**CITY OF PLANT CITY
Purchasing Department
(813) 659-4270**

ADDENDUM 4

**IFB No. 16 016UO-DB
Sanitary Sewer Lining Project**

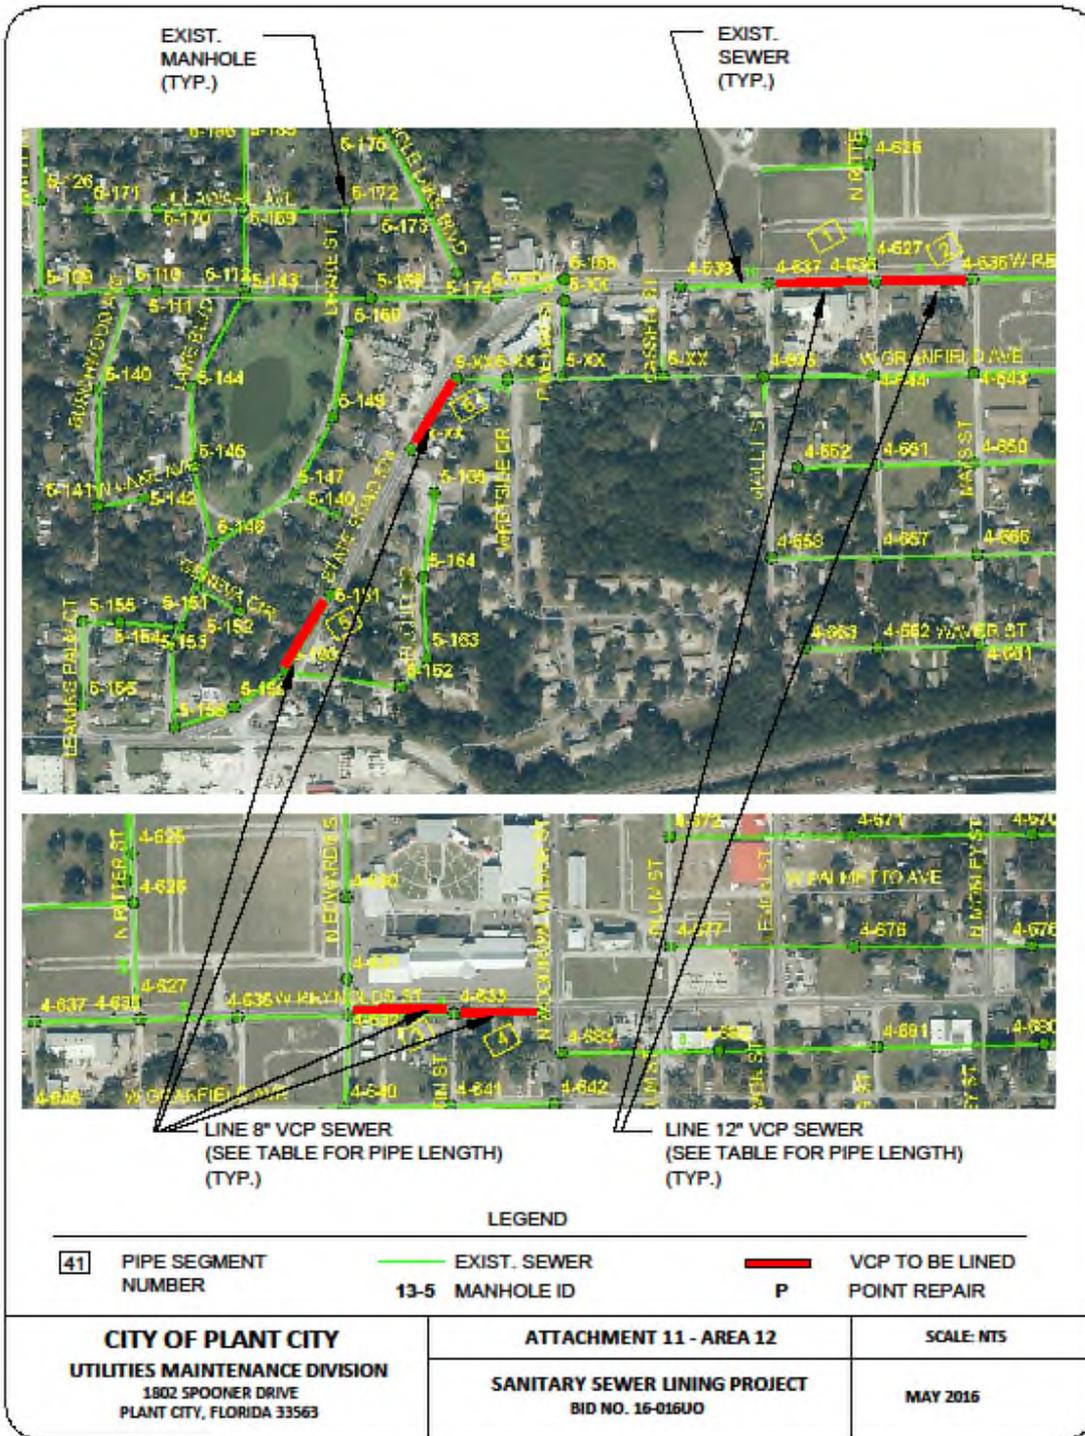
Area 12 – The work to be performed as follows:

Install cured in place pipe, lining 625 linear feet of 12-inch and 1130 linear feet of 8-inch VCP gravity sanitary sewer main within the right-of-way of Reynold Street (SR 574). The individual sewer runs are listed below:

<u>Pipe No.</u>	<u>Pipe ID</u>	<u>Manhole</u>	<u>Manhole</u>	<u>Length</u>
1	P-4-637	4-637	4-636	325
2	P-4-636	4-636	4-635	300
3	P-4-633	4-632	4-633	320
4	P-4-634	4-633	4-634	275
5	No ID	5-160	5-161	275
6	No ID	xx-xx	5-xx	260

Install cured in place pipe, lining as many as 26 service laterals including clean-outs and seal service laterals to main line.

The extent of the lining is shown on Attachment 11.

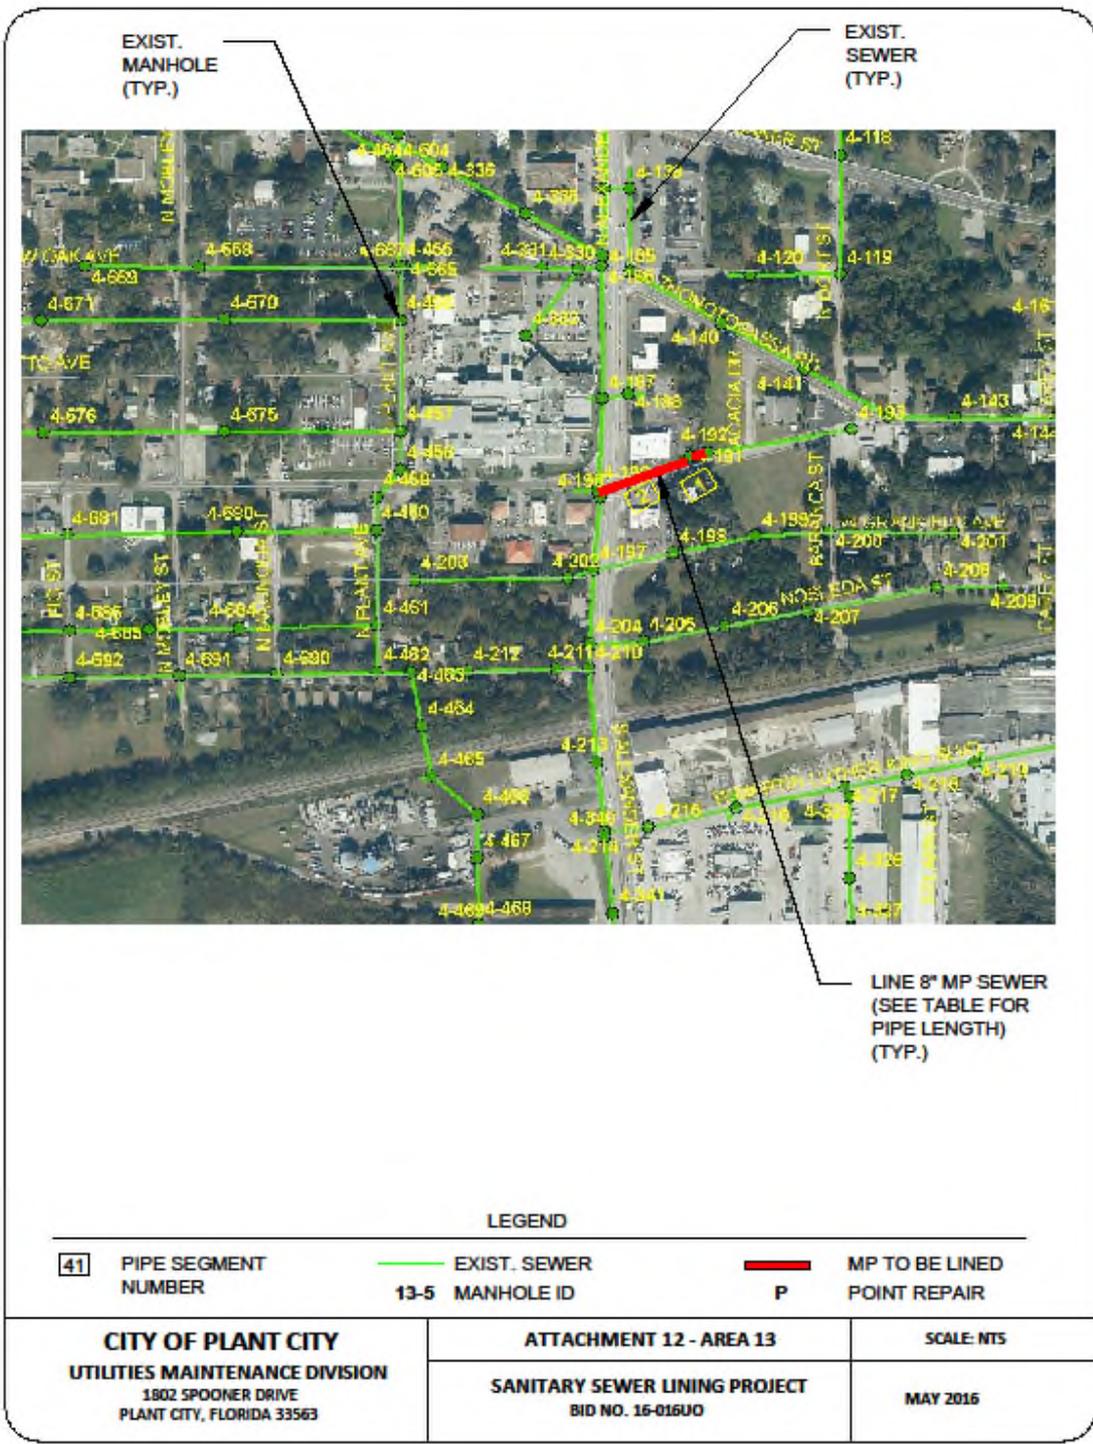
Area 13 – The work to be performed as follows:

Install cured in place pipe, lining 350 linear feet of 8-inch steel gravity sanitary sewer main within the right-of-way of Alexander Street and Reynolds Street (SR 39 and SR 574). The individual sewer runs are listed below:

Pipe No.	Pipe ID	Manhole	Manhole	Length
1	P-4-192	4-191	4-192	50
2	P-4-191	4-190	4-191	300

Install cured in place pipe, lining as many as 3 service laterals including clean-outs and seal service laterals to main line.

The extent of the lining is shown on Attachment 12.
